MIL-P-43607G
AMENDMENT 4
8 June 1992
SUPERSEDING
AMENDMENT 3
2 June 1987

PADLOCK, KEY OPERATED, HIGH SECURITY, SHROUDED SHACKLE

This amendment forms a part of Military Specification MIL-P-43607G, dated 18 June 1986, and is approved for use by all Departments and Agencies of the Department of Defense.

FIGURE 1. Example of padlocks with shrouded shackles.

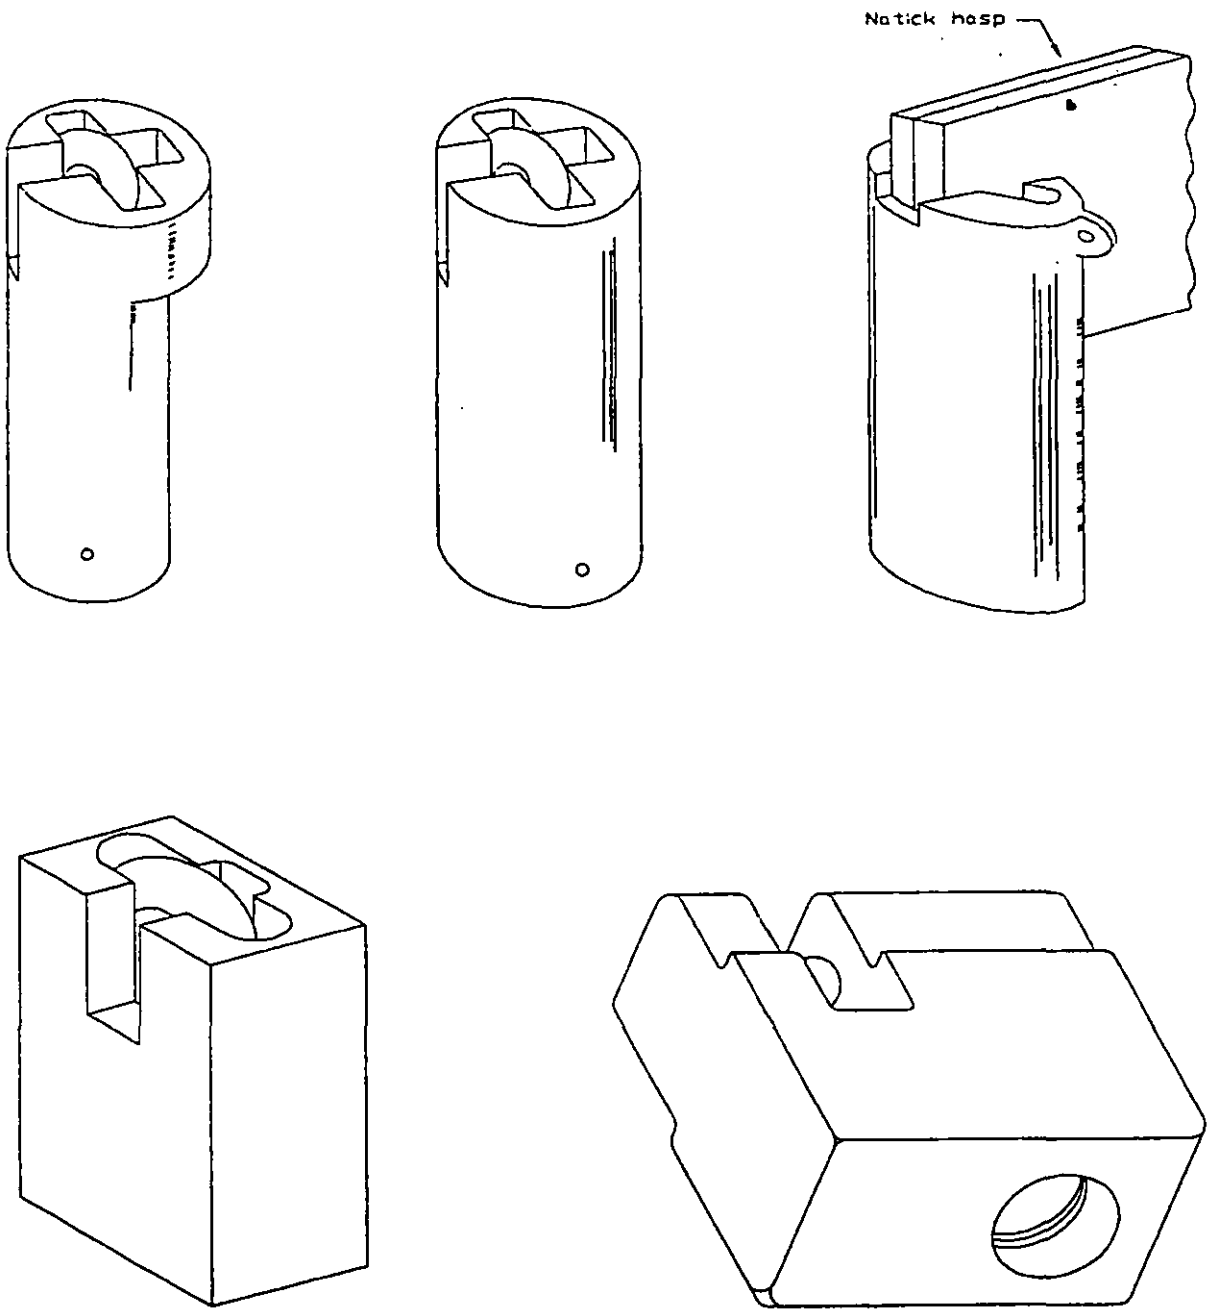
3.1: Delete and substitute:

* "3.1 Description. The shrouded shackle, high security padlock, hereinafter referred to as the "padlock," shall be a single, key operated type (proprietary military keyway) utilizing a special key for disassembly. Padlocks shall be keyed individually. The padlock body or case shall extend beyond the shackle as a shield. The extension shall extend 0.125, +0.010 or -0.050 inch (3.175, +0.254 or -1.270 millimeter (mm)) beyond the top of the shackle when the padlock is locked closed and suspended on a hasp. The extension shall also provide a shield on all sides of the shackle except at the throat opening provided for the hasp. The periphery (girth) of the body or case (measured on a plane perpendicular to the long axis of the padlock) shall be of approximate uniform outside dimensions extending from the bottom, through the midsection, and to the top of the extension except for minor deviations required for indentations, notches, and taper for fit and appearance. The configuration shall provide for close mating with the hasps specified herein. The padlock, locked on these special hasps, shall constitute a locking system highly resistant to forced and surreptitious entry as detailed within this specification. A unit, as referred to herein, shall be one completely assembled padlock with keys. See figure 1 for examples of padlocks with a shrouded shackle."

FIGURE 2. Key nomenclature.

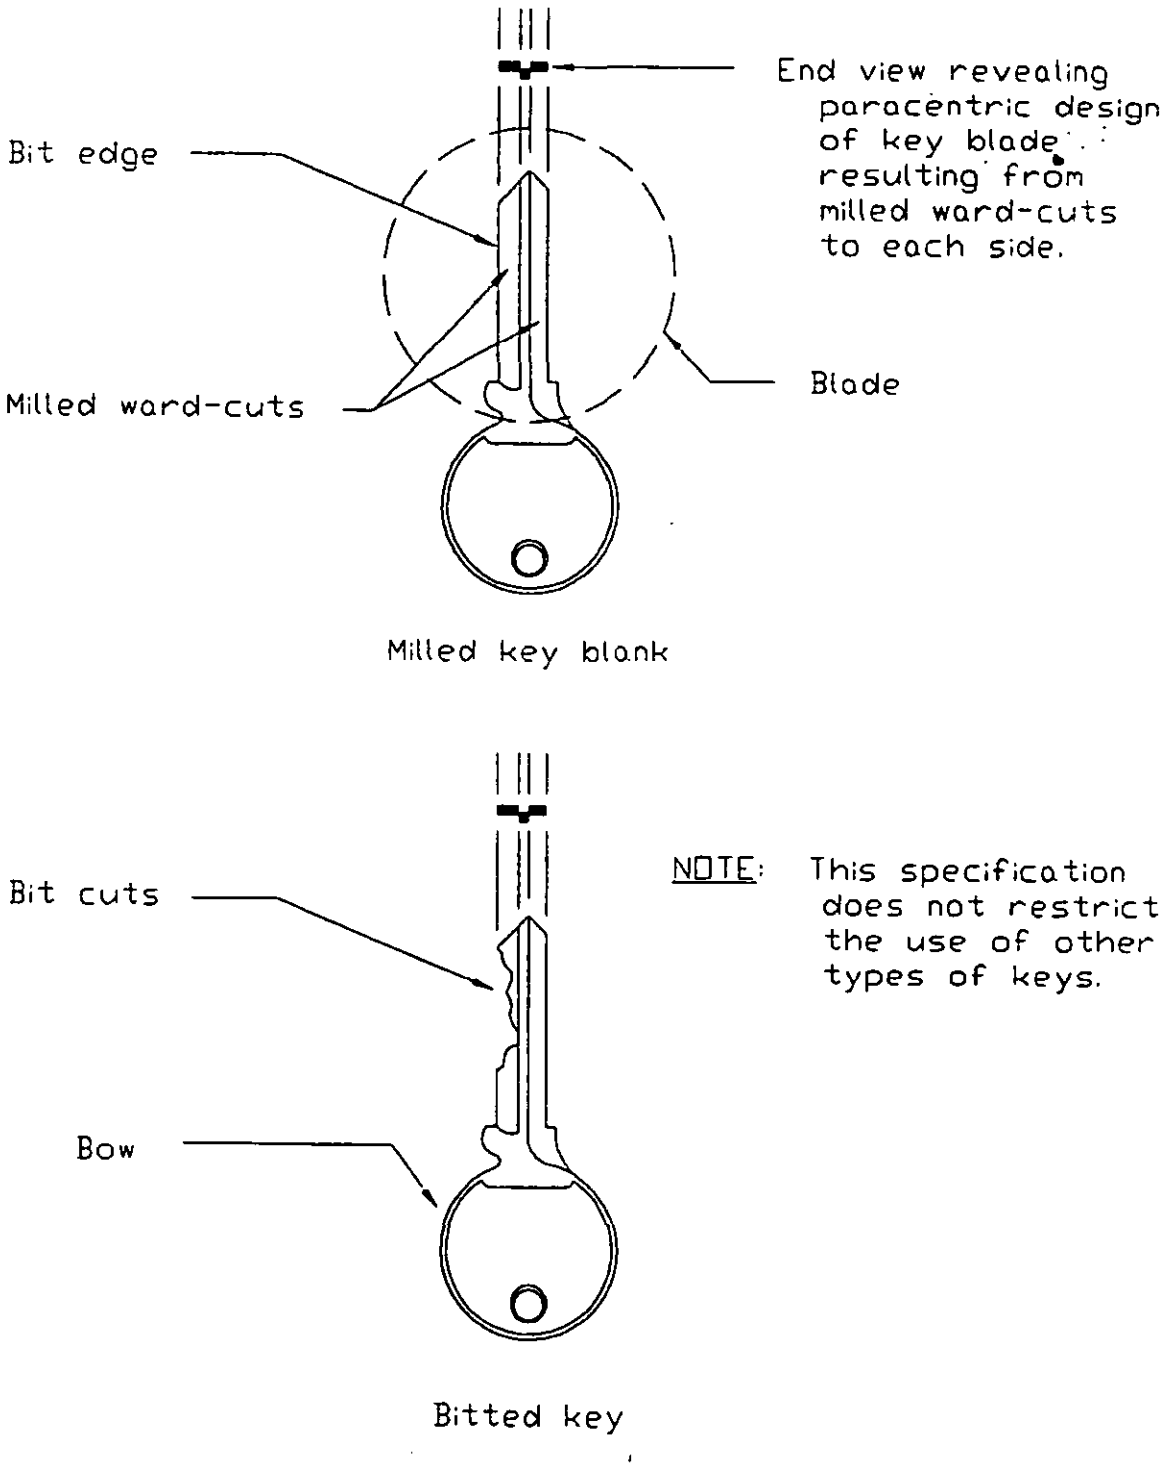
3.6.3.2: Change to read:

* "3.6.3.2 Key. The padlock shall be furnished with three keys: two operating keys and one control key. Terms for parts of keys used herein are defined below and shown on Figure 2. However, the design of the lock is not to be restricted to only that type of key.

Bow - The handle, or head, of a key. On a cylinder key, that part beyond the shoulder that does not enter the keyway and by which the key is held and turned.

Blade - Part that is inserted into the lock cylinder key way.

Bit - The section of a key that enters a lock, which has the key cuts formed in it and which engages the bolt or tumblers of the lock. The bit is called a blade in the case of a cylinder lock.

Bit Key - A key with a blade, called a bit, which projects from the side of a round shank near the tip and on which are made key cuts to clear the wards on a warded lock.

Key Cut - A square, rounded or V-shaped depression, filed or machined into a key. In tumbler locks, the series of key cuts on a key causes the tumblers to line up at the shear line or gate so the lock will open. In warded locks, the key cuts bypass the wards so the key can push or pull the bolt.

Key Section - The shape of a key blade in cross section, viewed in the plane perpendicular to the length of the blade. The key section is determined by the shape of the keyway it fits."
